RE: **Lot 11 Block 4 Unit 22 SAD 228
6409 Canavio Rd. NW
Volcano Cliffs Subdivision
Grading and Drainage Plan
Engineers Stamp Date 1/25/2022 (D10D003D11)**

Based upon the information provided in your submittal received 3/16/2022, this plan is approved for Grading Permit.

PROJECT NAME: GRADING AND DRAINAGE PLAN

PROJECT NAME: ALBERTI-LAMPHERE RESIDENCE

G1

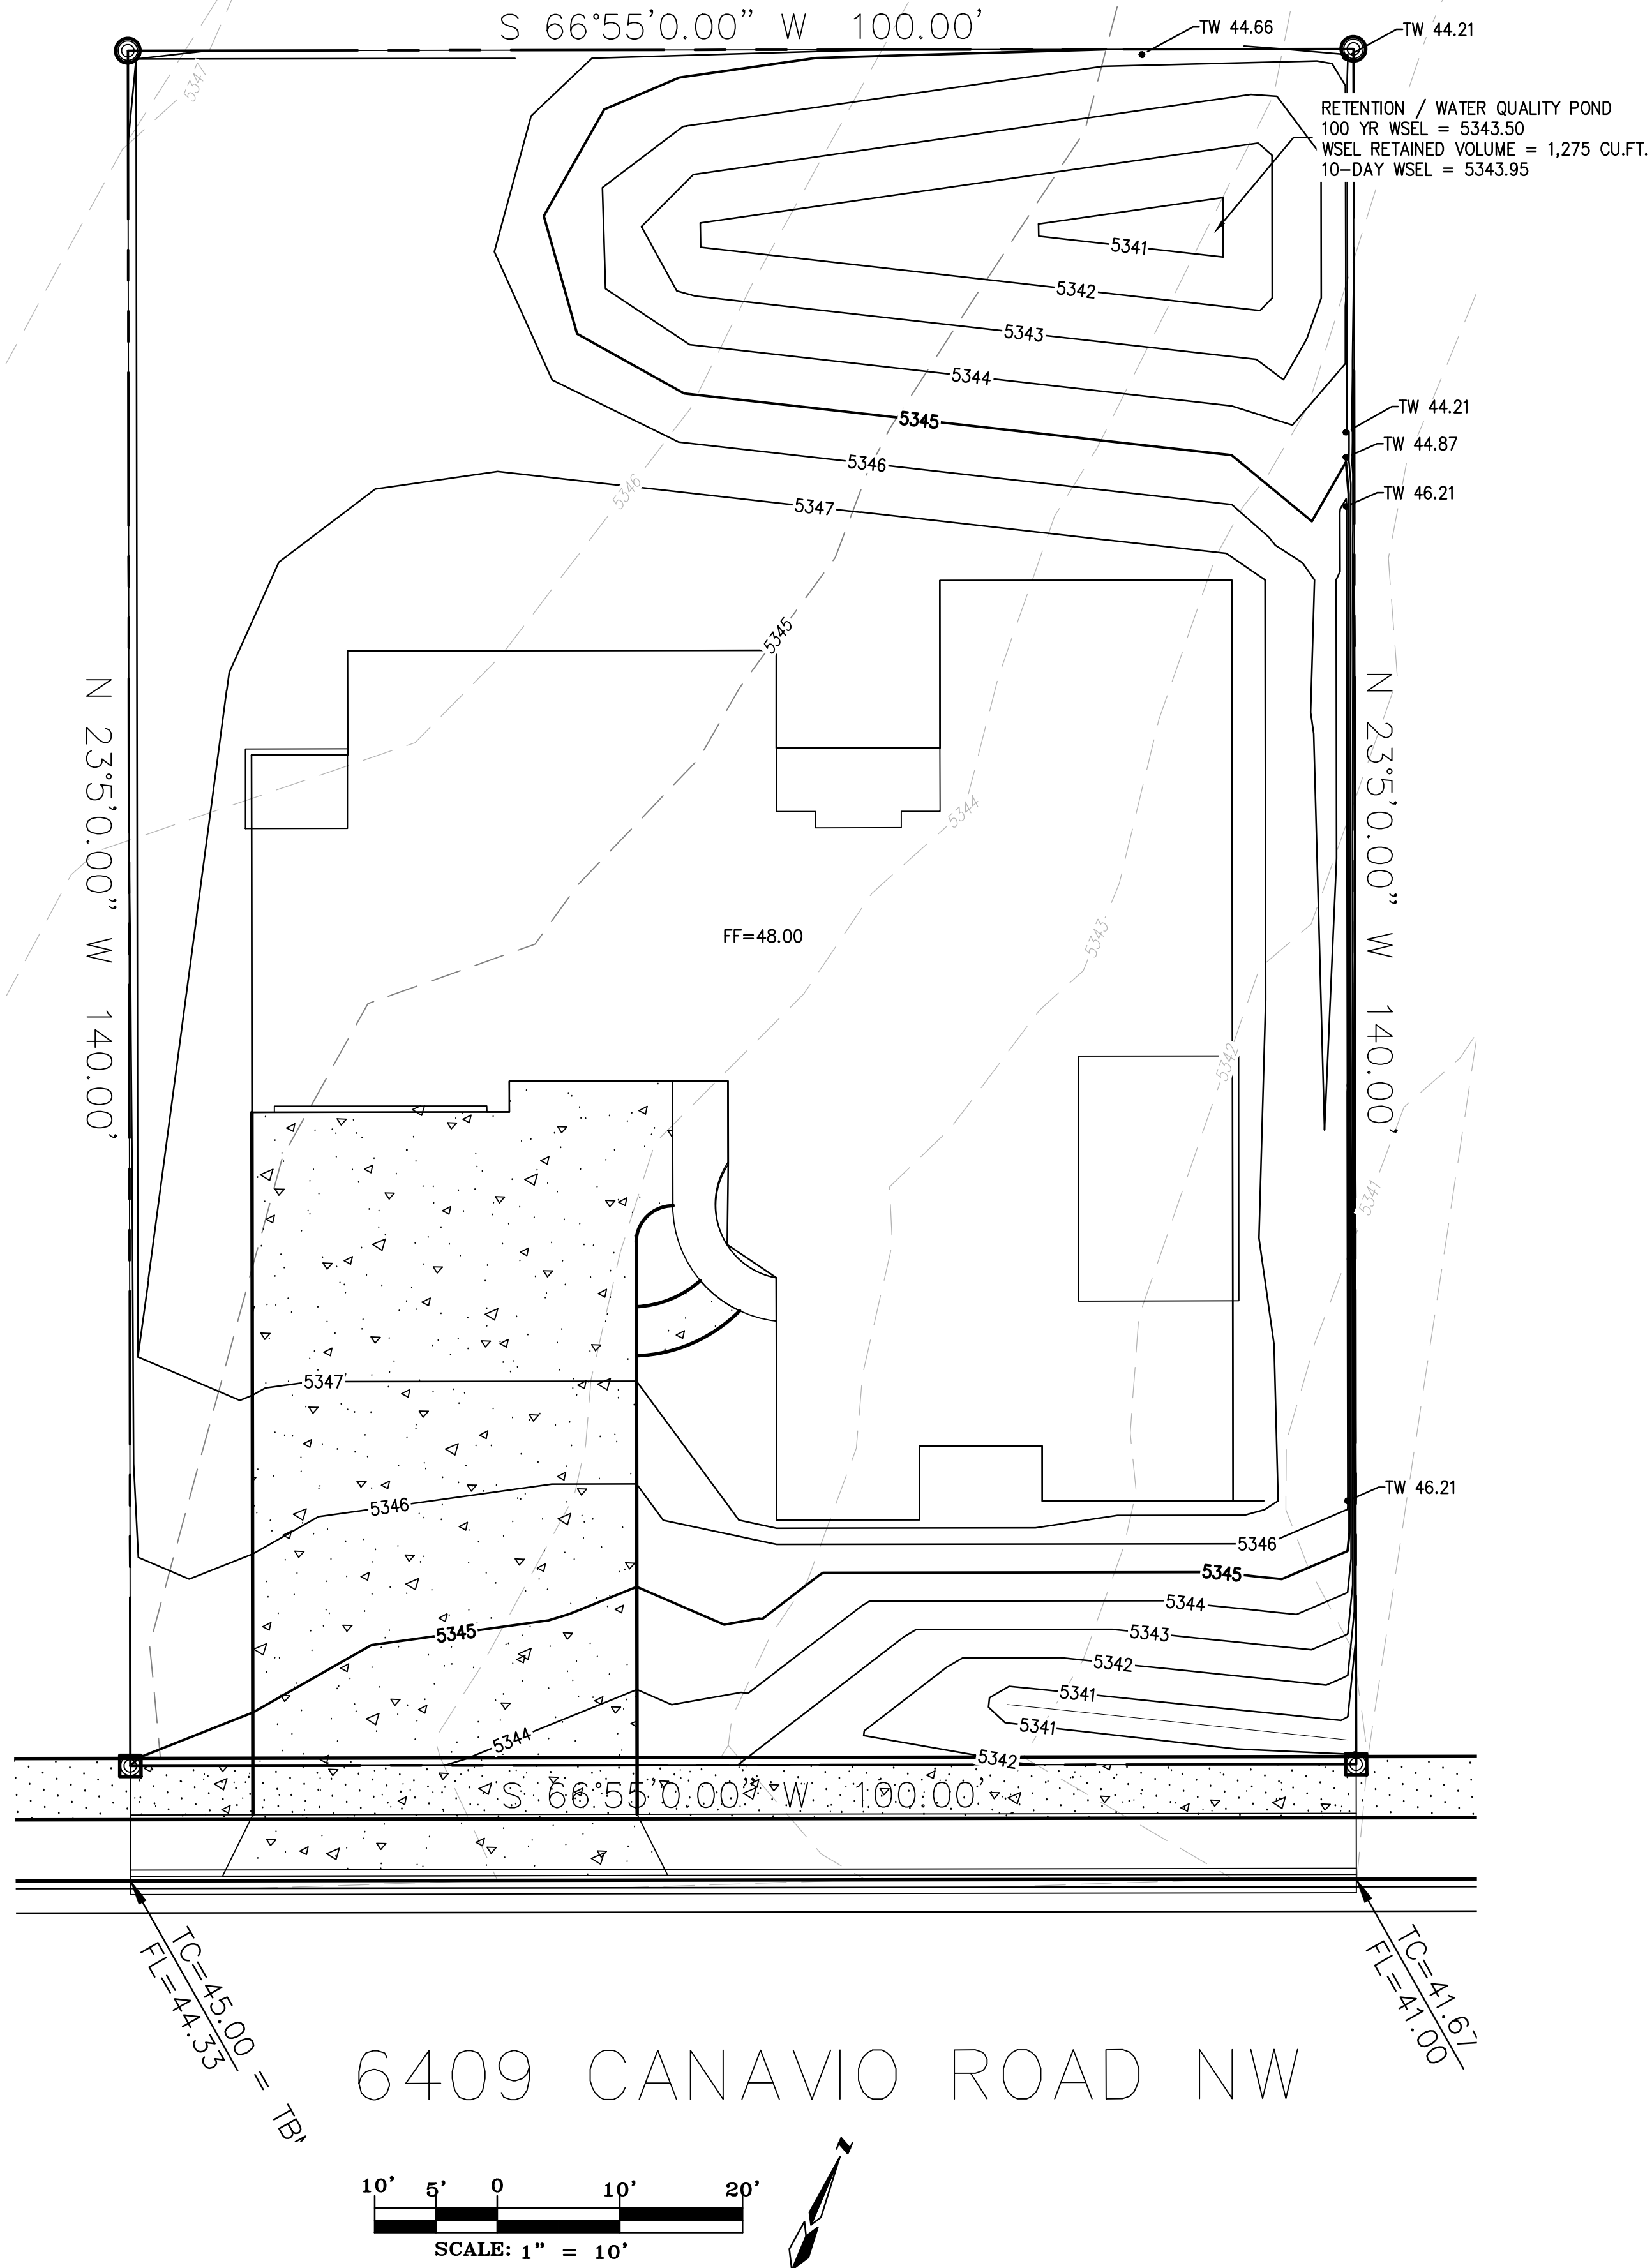
Advise the owner contractor not to use dirt as a ramp to climb the curb, use lumber or crusher fines for this purpose. Place this note on the plan.

Reiterate to the Owner/Contractor that a separate permit for a garden/retaining wall must be obtained with the approved G&D plan and Pad Certification. Also, if a swimming pool is to be placed after this approval a new grading and drainage plan will need to be resubmitted showing the changes for the land treatments.

This letter is to serve as notice of our intent to use a wood “ramp” to access the lot at 6409 Canavio Rd. NW.

We will not be placing any dirt in the right of way.
